## **Proof of Evidence**

Network Rail Level Crossing Closures – Essex

Colchester Borough Council

### **Crossing E52 Golden Square**

**Alternative Breach Point**

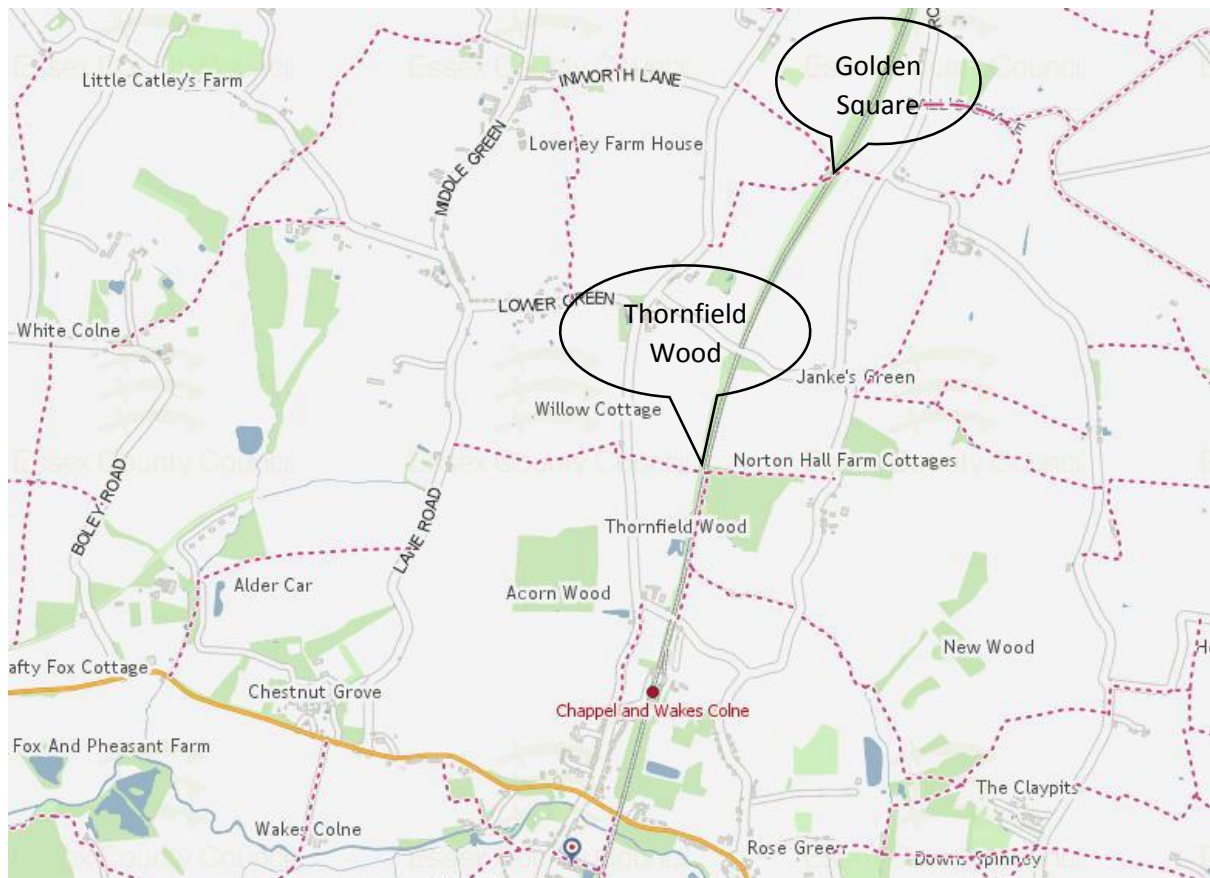
23. If the crossing is closed, it is recommended that to overcome this issue, the breach point is moved 70m or so west where there is naturally occurring 10m or so wide gap in the hedge. This would allow for a connection to be implemented without requiring any actual removal of the important hedgerow. (see appendix B – alternative breach point).

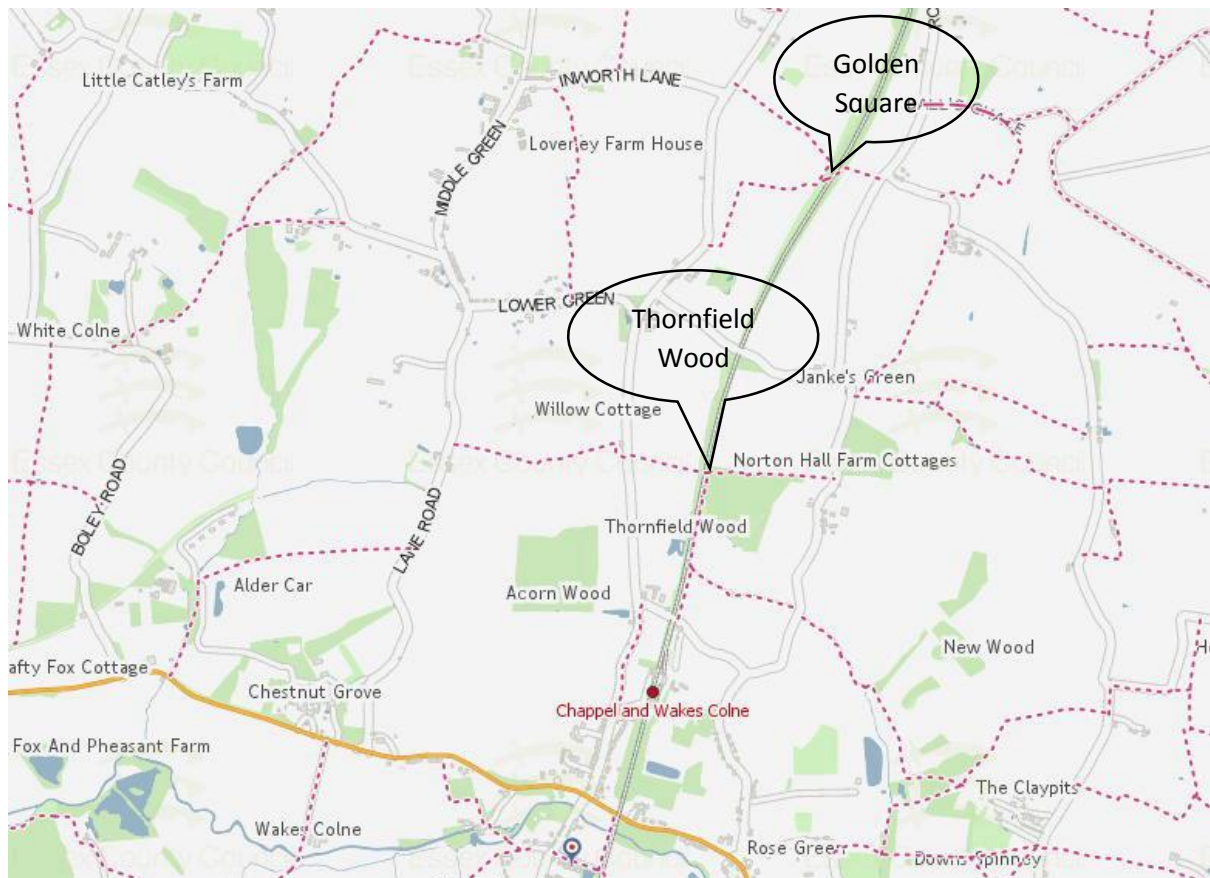
22. CBC proposed an alternative routeing of the new path to avoid the need to remove part of the Hedgerow. The hedgerow in this area is categorised as “important” using the Hedgerow Act of 1997. (see Appendix B). Network Rail have proposed make the connection back to the road (Drawing MMD-367516-E51-GEN-005, March 2017) to the east of the wood (at point P242, sheet 35, folder 03, 2of2, March 2017) but this still needs the removal of part of the

“important” hedgerow. The new connection point brings the path out into a section of the road where the lane is partially sunken as aforementioned (see Appendix B).

*Figure 1 E51 Thornfield Wood Diversion – Looking west, “important” Hedgerow on left - proposed connection point (P242) close to telegraph pole*

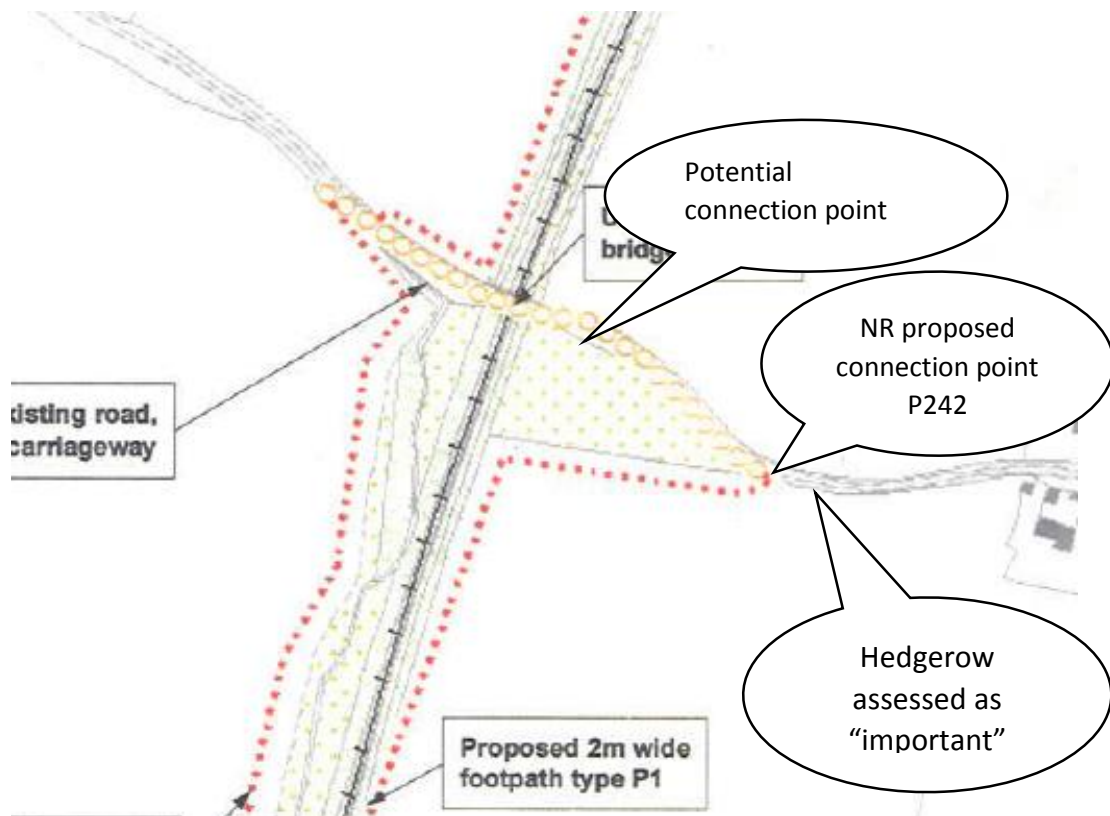
*Figure 2 E51 Thornfield Wood Diversion – Looking east, proposed connection point (P242) close to lady in blue through “important” hedgerow. Note 1.5m high bank on the left.*
